HISTORIC AND DESIGN REVIEW COMMISSION

February 02, 2022

HDRC CASE NO: 2022-063
ADDRESS: 109 BEVERLY DR
LEGAL DESCRIPTION: NCB 9076 BLK LOT E 50 FT OF 20 & W 35 FT OF 21
ZONING: R-6,H
CITY COUNCIL DIST.: 7
DISTRICT: Monticello Park Historic District
APPLICANT: Martha Arredondo
OWNER: Martha Arredondo
TYPE OF WORK: Installation of a chimney cap
APPLICATION RECEIVED: January 04, 2022
60-DAY REVIEW: Not applicable due to City Council Emergency Orders
CASE MANAGER: Stephanie Phillips
REQUEST:

The applicant is requesting a Certificate of Appropriateness to install a metal cap atop the existing limestone veneer chimney located on the front façade.

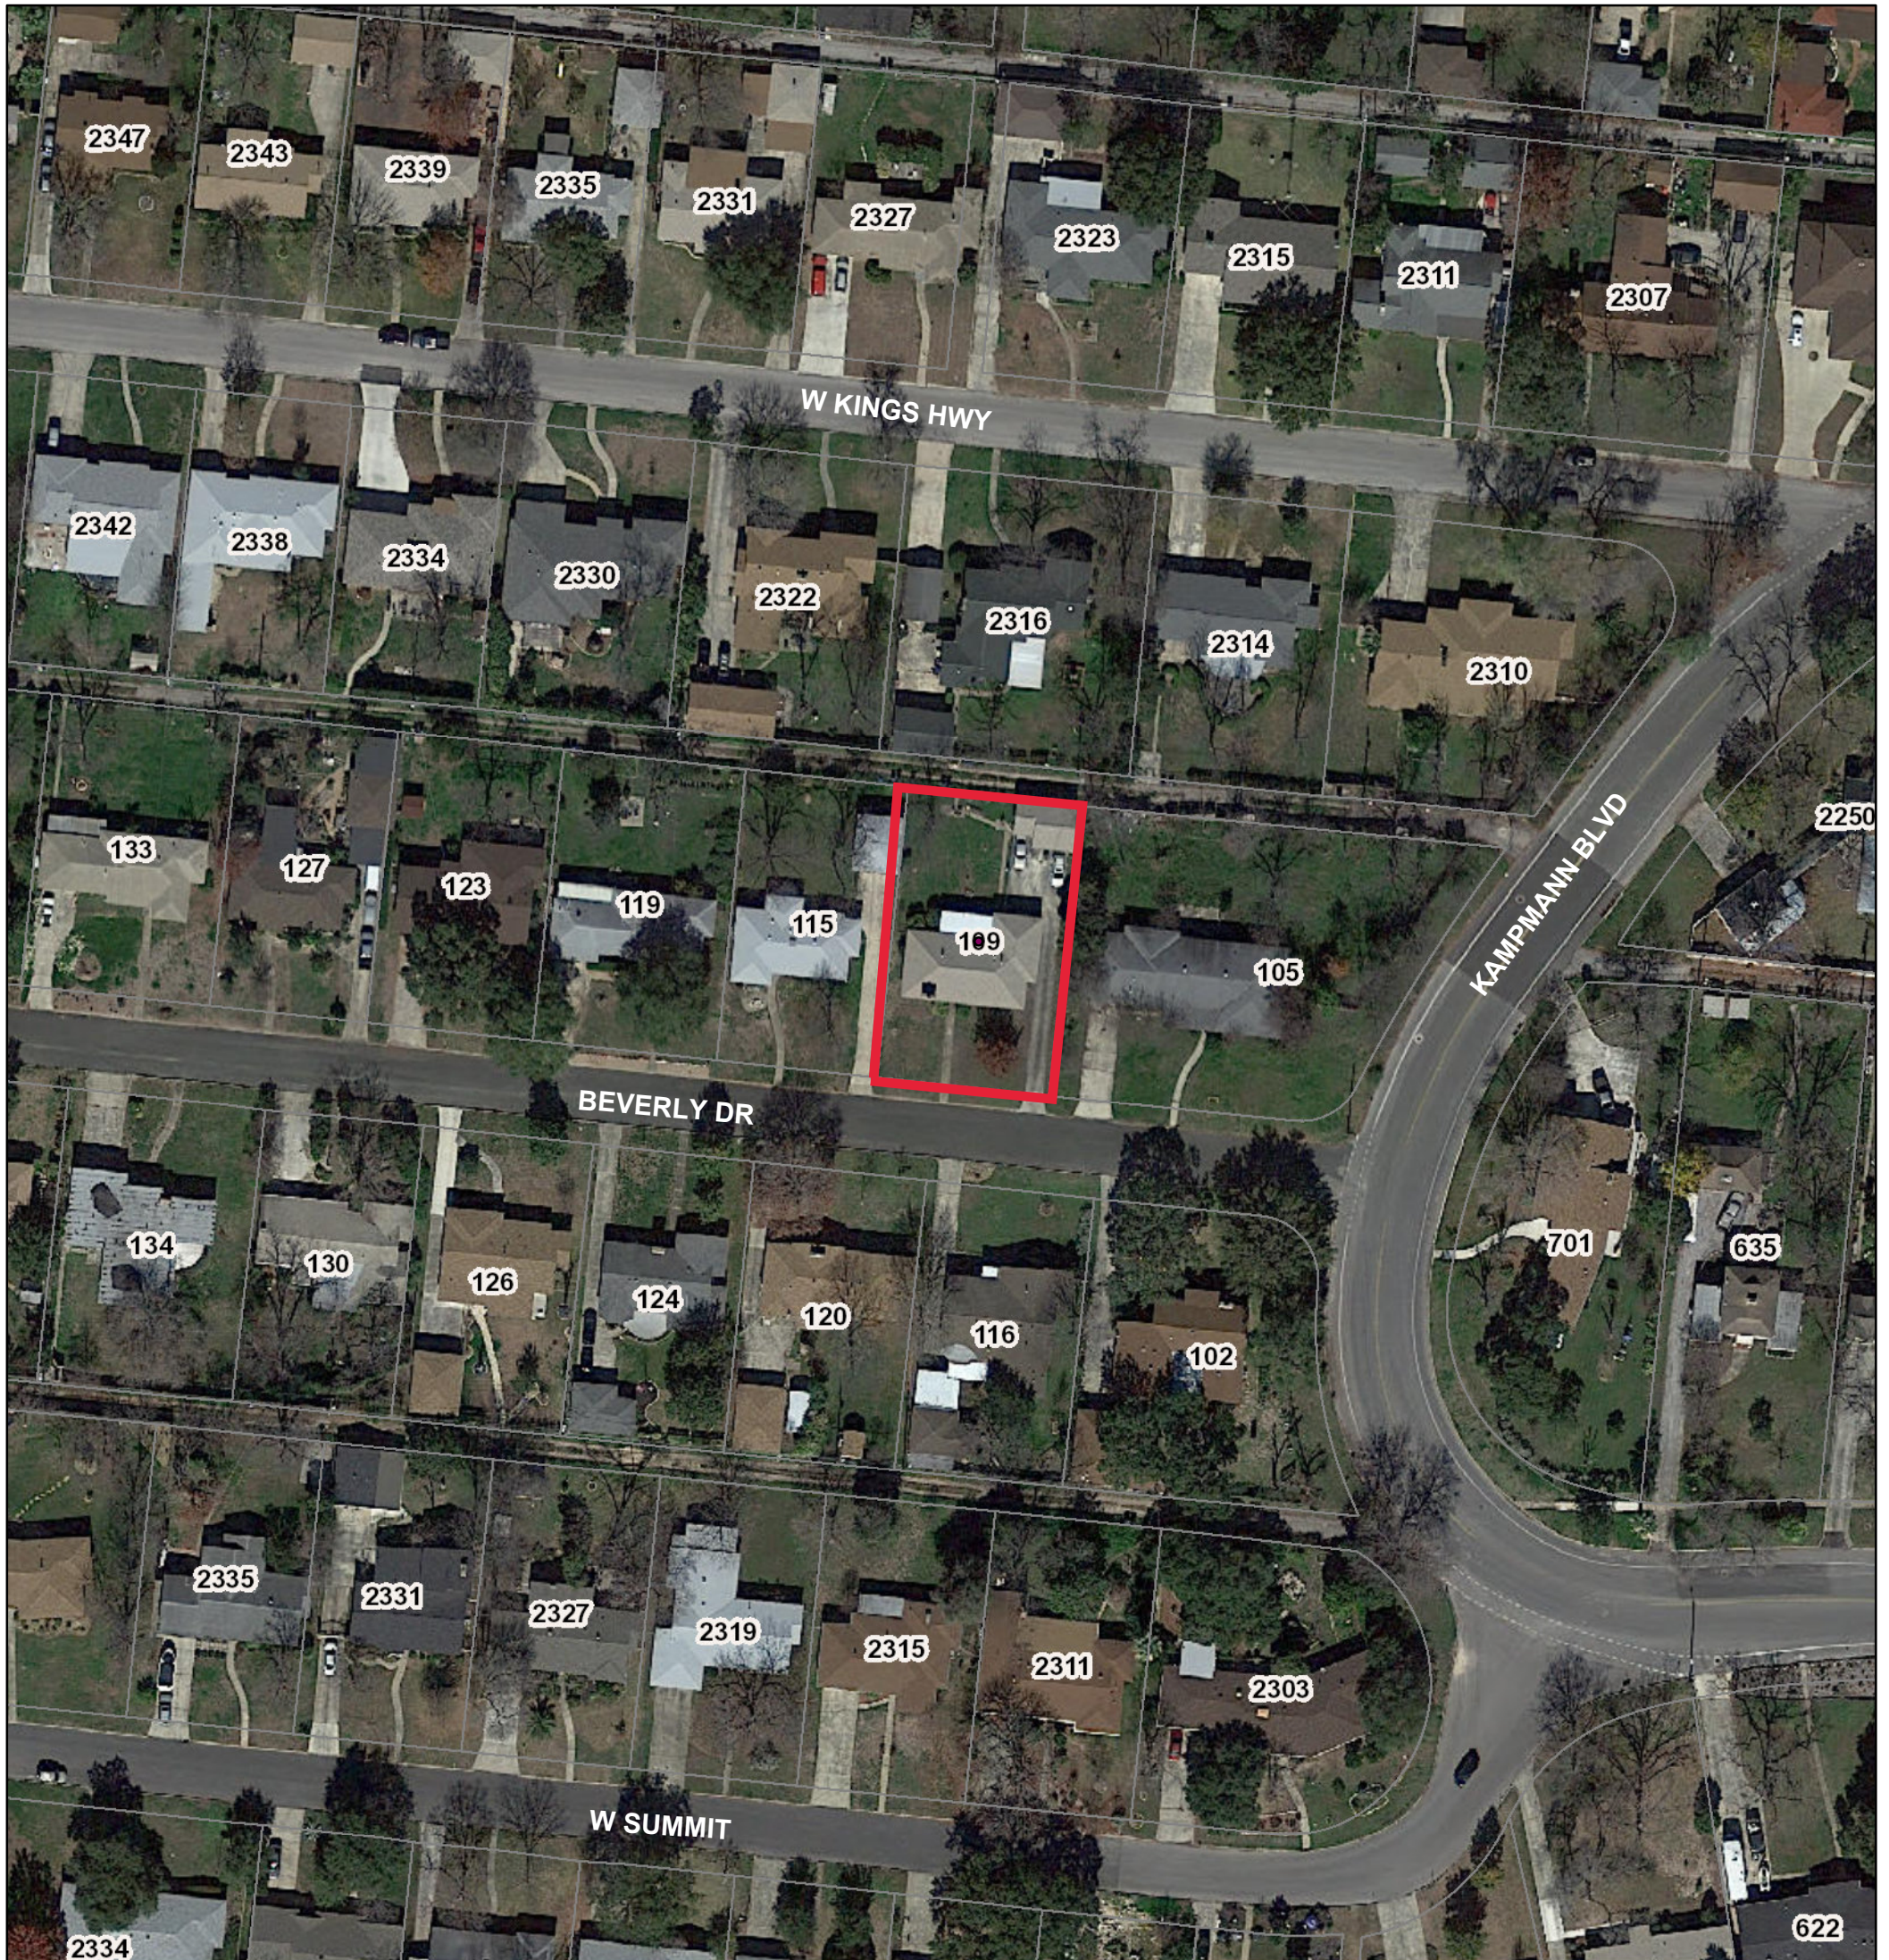
- b. CHIMNEY CAP – The applicant has proposed to install a metal cap atop the existing limestone veneer chimney located on the front façade. The cap is requested to prevent long-term damage to the currently inoperable chimney. Per the submitted application, the cap will be 24-gauge colored powder coated steel with a standing seam hood. Per the Historic Design Guidelines, new roof features should be compatible with the style of the home and should not obscure architectural features. Staff overall finds the proposed cap compatible and reversible, but finds that the wrapped metal base should be removed as to not obscure the character-defining, angular detail of the top of the existing chimney.

Staff recommends approval of the proposed chimney cap based on findings a and b with the following stipulations:

- i. That the wrapped metal base of the proposed cap design be removed as to not obscure the character-defining, angular detail of the top of the existing chimney. An updated specification is required prior to the issuance of a Certificate of Appropriateness.
- ii. That the cap be installed in manner that is fully reversible and does not inflict damage on the limestone veneer.
